SUBJECT: Final Subdivision Plan to establish a 499-foot length street, north of Barlow Road to establish two (2) sublots to be located at 1221 Barlow Road, Permanent Parcel #3010196.

PC Case No: 2018-4811

Re: **Public Roadway Plans & Plat for Flood Meadows Drive Engineering Review**

PLAN AND PROFILE

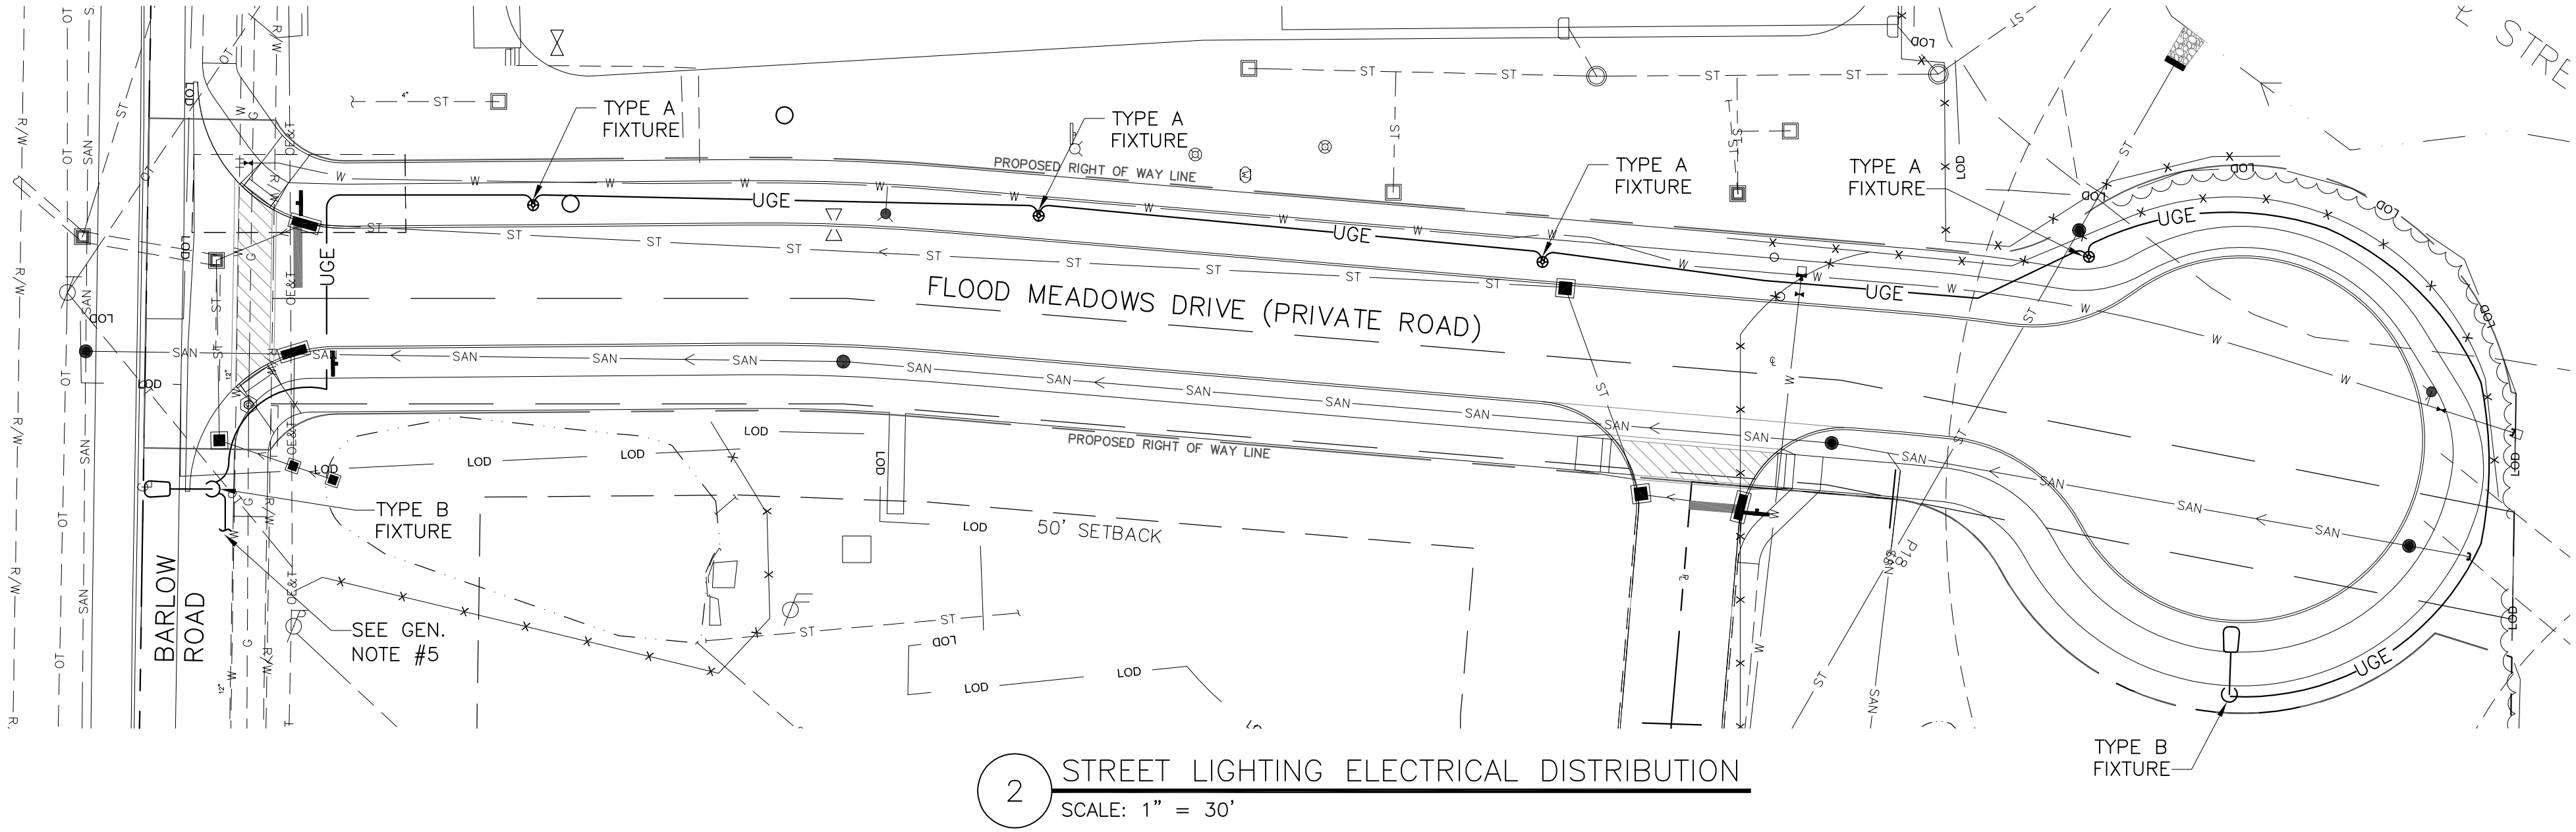
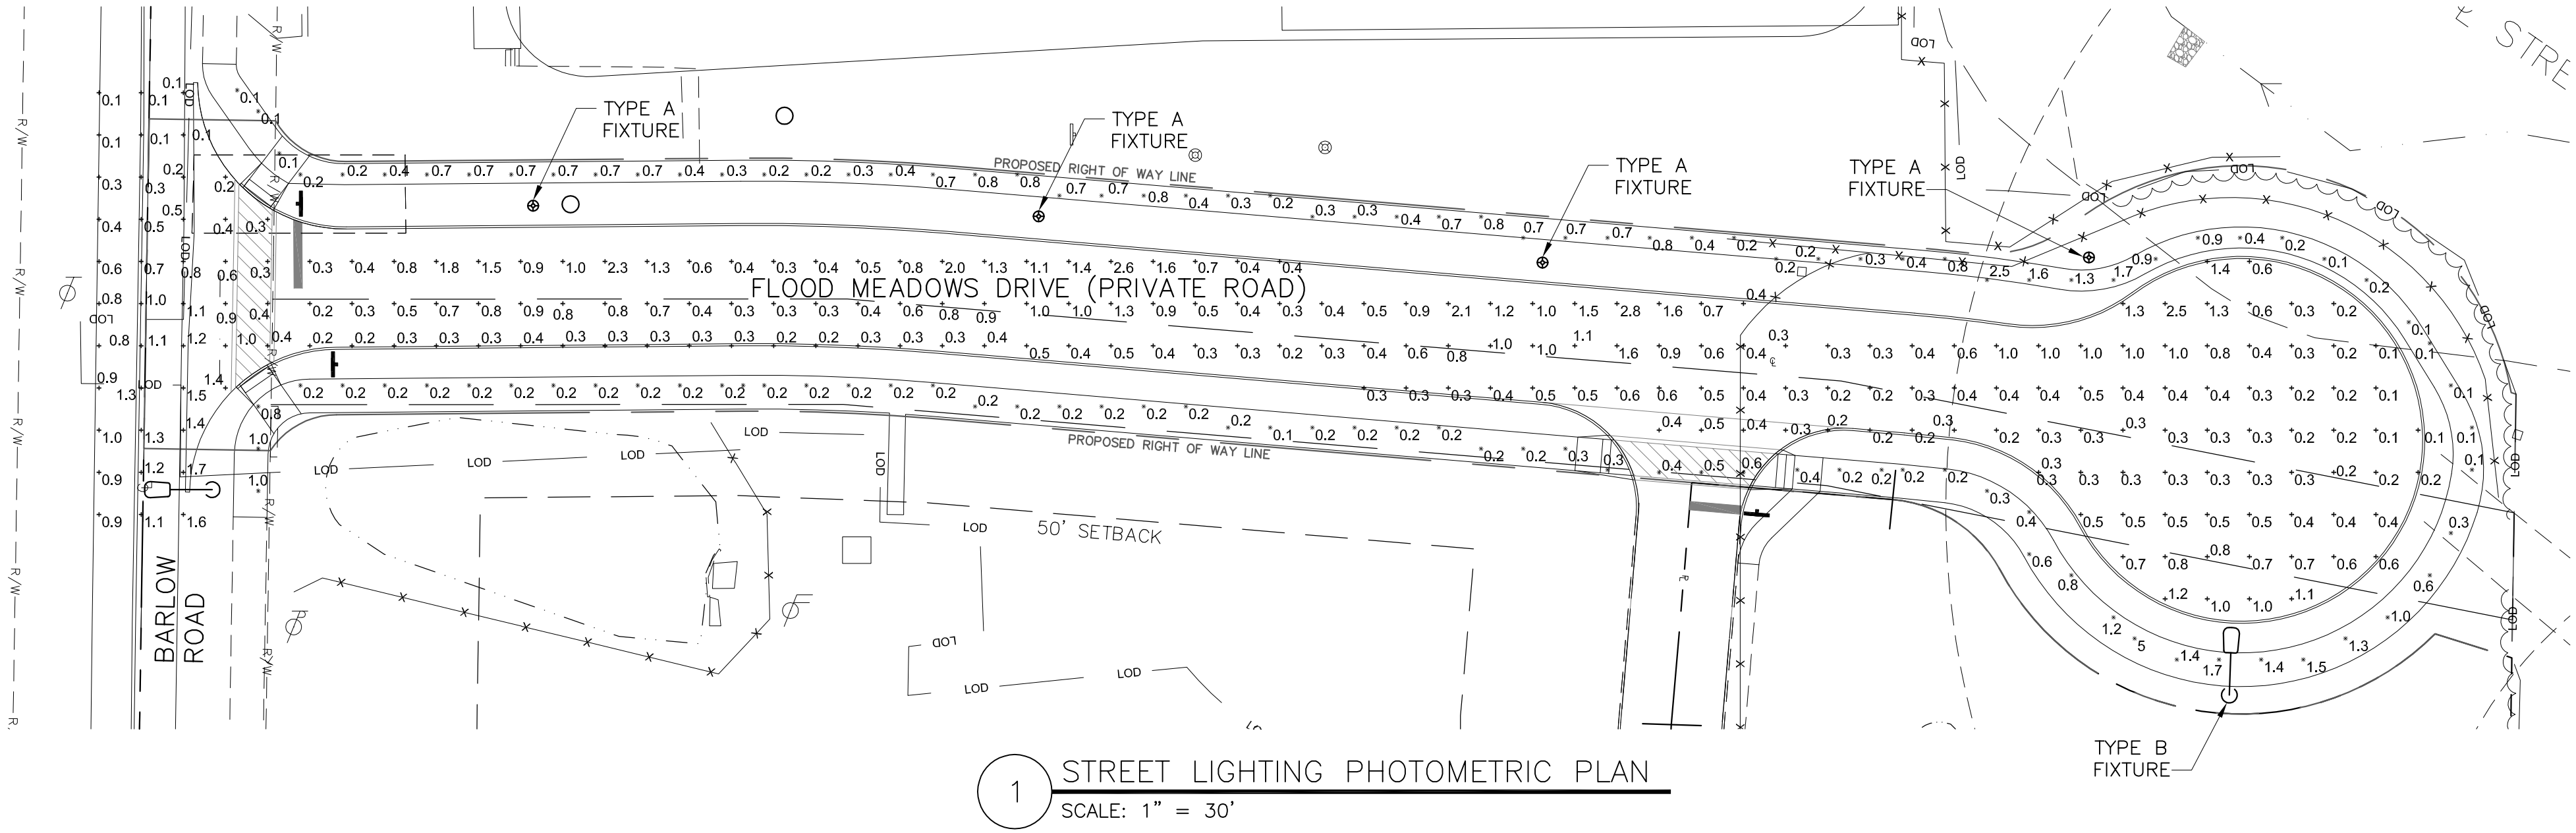
3. Sheet 2 – The note near the crosswalk states “See sheet 10 for signage and pavement marking details”. These details are not on sheet 10. Please provide pavement marking and signage details.
